**Pipeline and Hazardous  
Materials Safety  
Administration**

Ref. No. 14-0117

This responds to your June 10, 2014 request for clarification of the rear-end protection requirements for cargo tanks under the Hazardous Materials Regulations (HMR; 49 CFR Parts 171-180). Specifically, you request clarification of rear-end tank protection requirements based on the design requirements of § 178.345-8(d)(1).

**From:** INFOCNTR (PHMSA)  
**Sent:** Tuesday, June 10, 2014 12:34 PM  
**To:** Drakeford, Carolyn (PHMSA)  
**Subject:** FW: Rear End Protection for cargo tanks 178.345-8(d)  
**Attachments:** Carogtankrearendprotectionsketch.pdf; Compliance with 178.345-8(d).ppt

178.345-8 (d)(1)

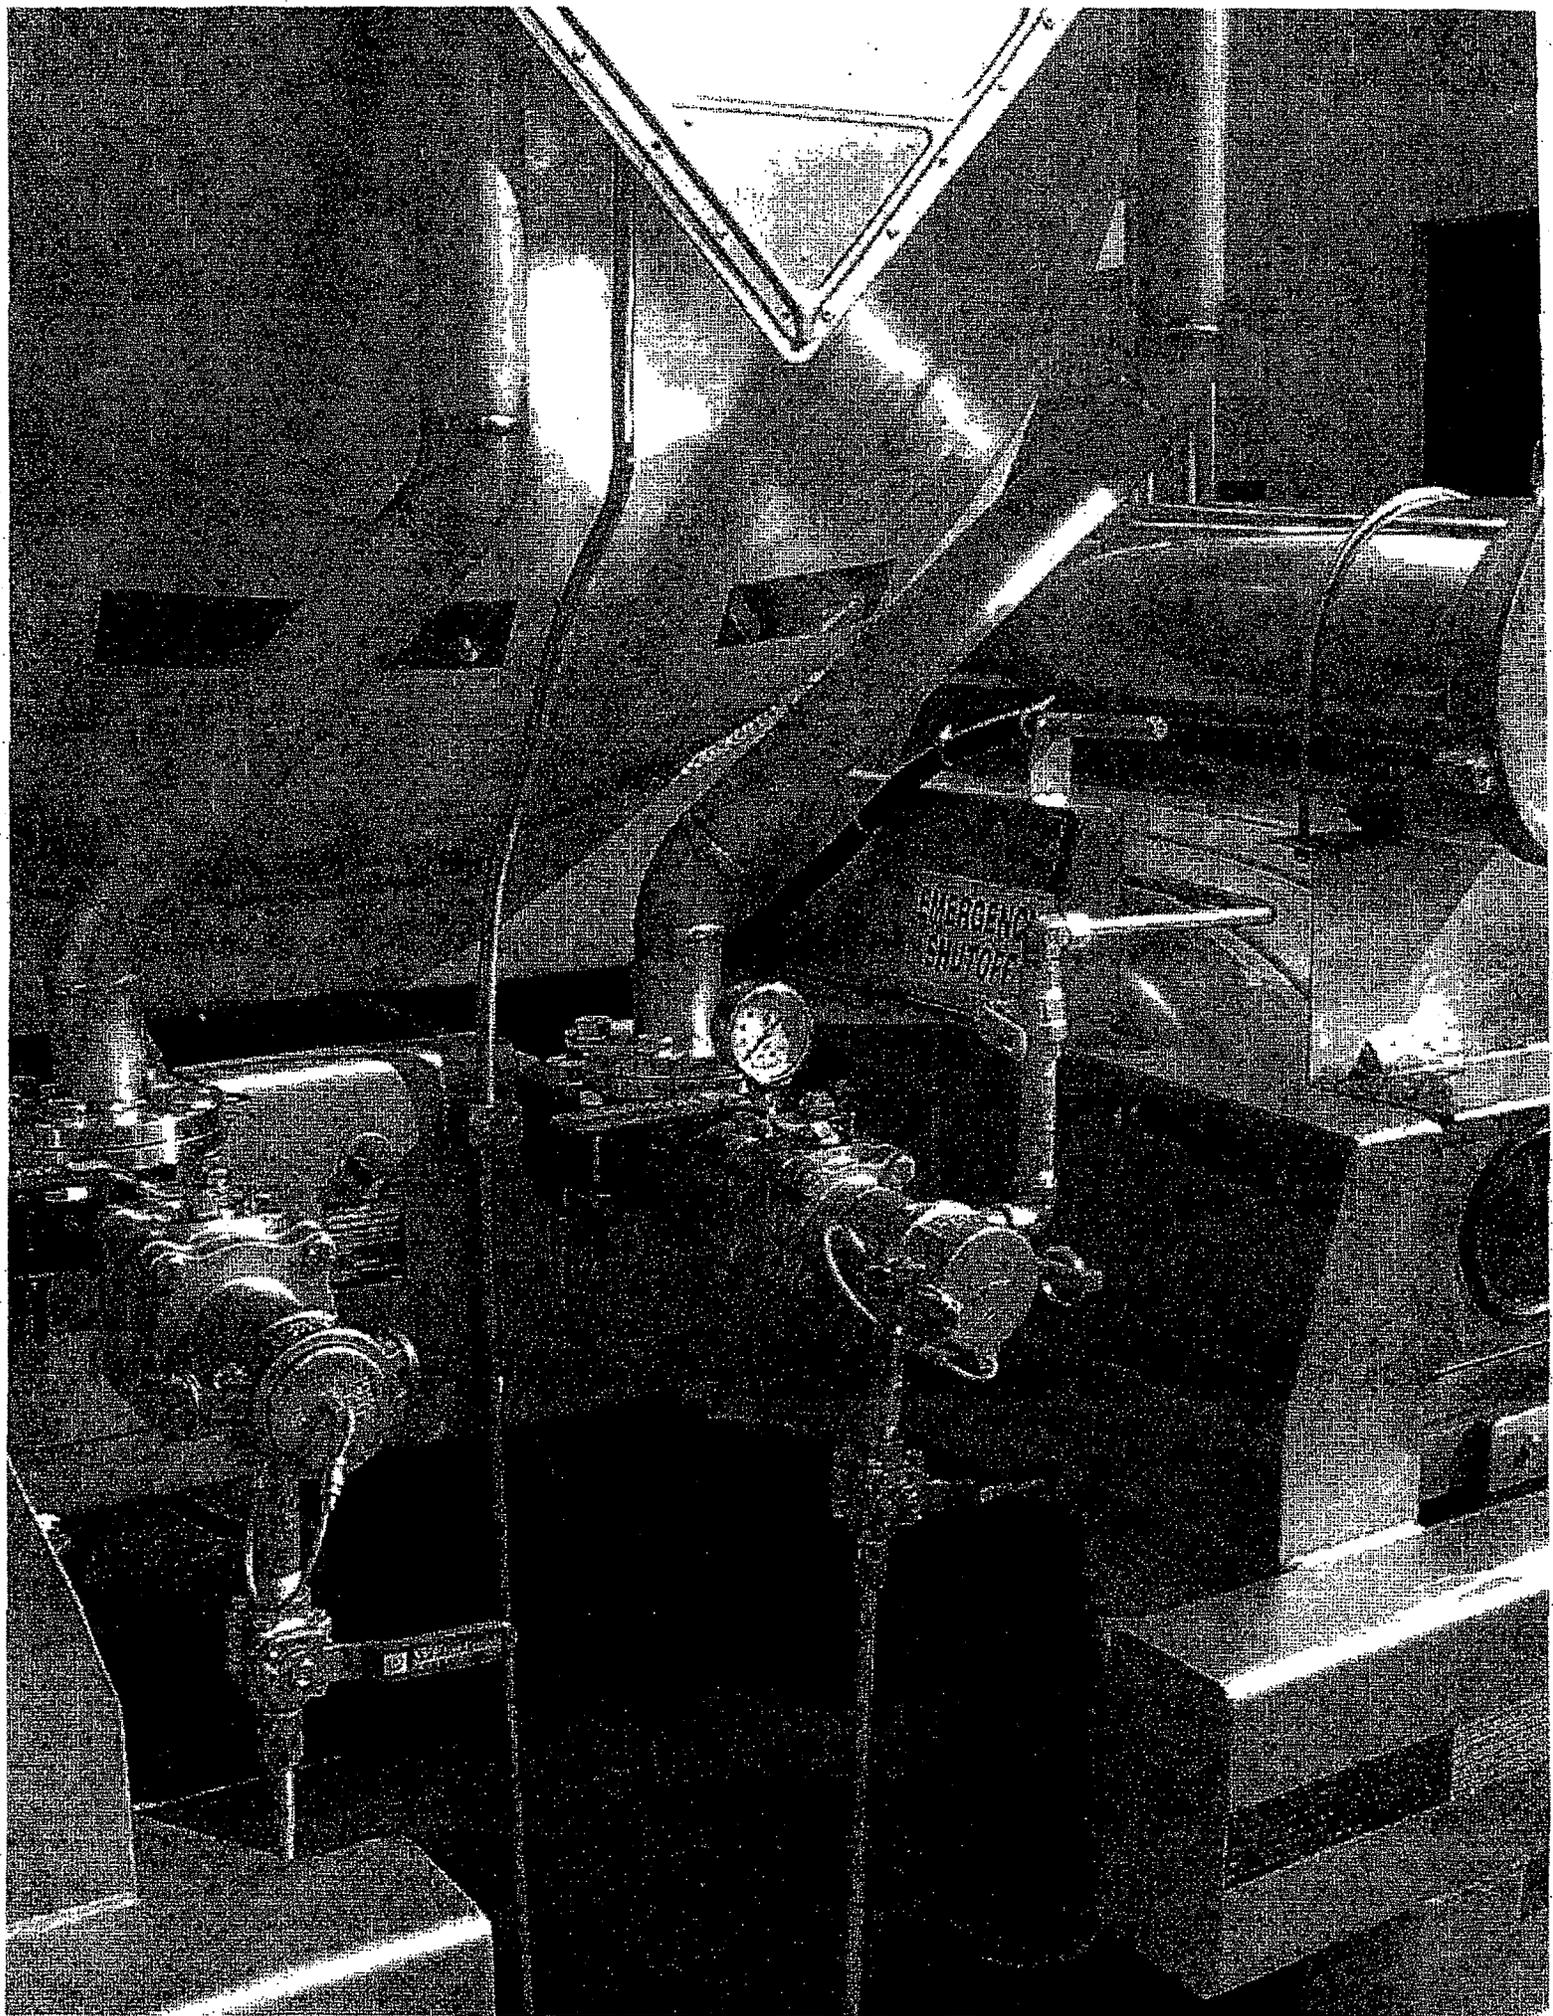
One of Arkema Inc. cargo tanks was stopped by state police and given a warning. The policeman stated the rear discharge pipes are less than 6" from the rear protection. They were only 3 1/4". Thus, claiming we violated 49CFR 178.345-8(d).

We contend that we were not in violation based on the second part of 178.345-8(d)(1):

Please see attached sketch of our trailers rear end.

Please confirm that we are correct.

The rear-end cargo tank protection device must be designed so that it can deflect at least 6 inches horizontally forward with no contact between any part of the cargo tank motor vehicle which contains lading during transit and with any part of the rear-end protection device, or with a vertical plane passing through the outboard surface of the protection device. If the piping is not in the horizontal plane of the bumper, then the 6 inch standard must be measured to a vertical plane passing through the outboard surface of the device. Furthermore, we expressed concern regarding the drain lines from the piping in that they are clearly in the horizontal plane of the bumper. Please be aware that drain lines from piping must also be in compliance with § 178.345-8(d)(1).

**178.345-8(d) Rear-end tank protection:**

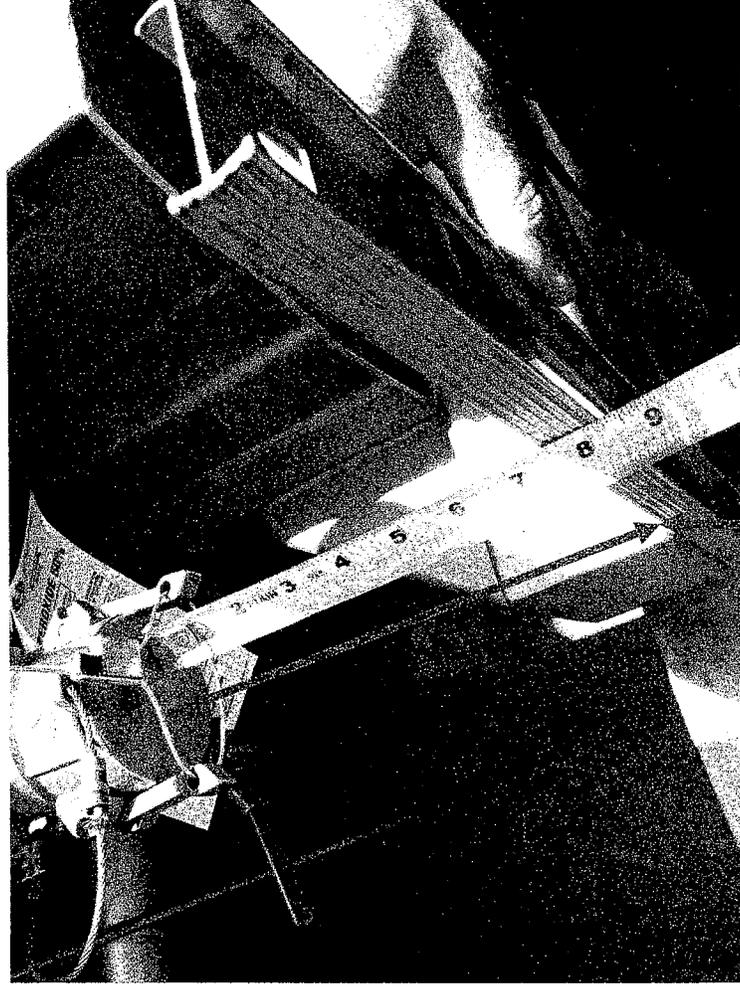
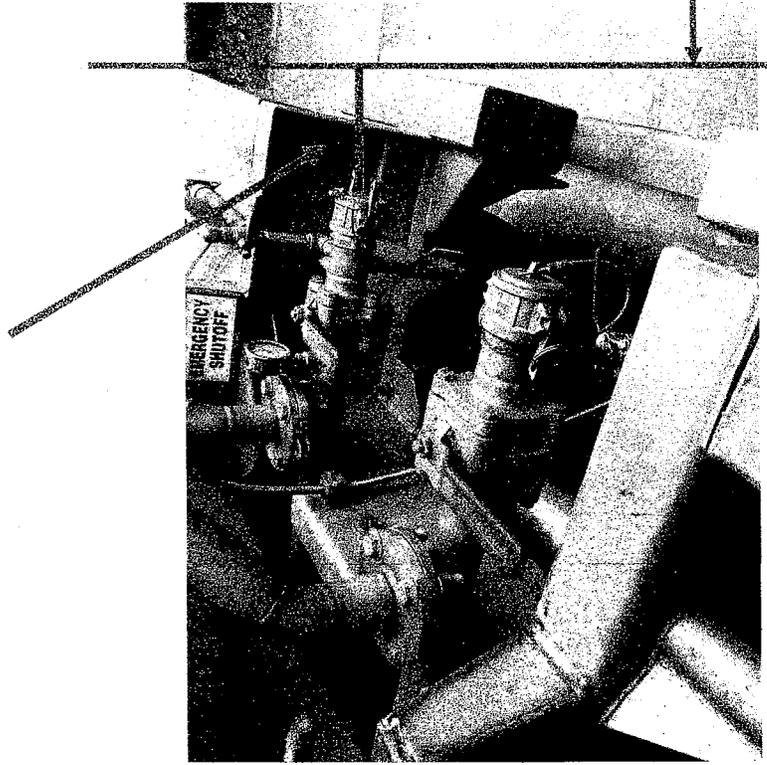
- (1) The rear end cargo tank protection device must be designed so that it can deflect at least 6 inches horizontally forward with no contact between any part of the cargo tank which contains lading during transit and with any part of the rear-end protection device, **OR** with a vertical plane passing through the outboard surface of the protection device.

Must be at least 6 inches

Vertical plane placed on the outboard surface of the protection device
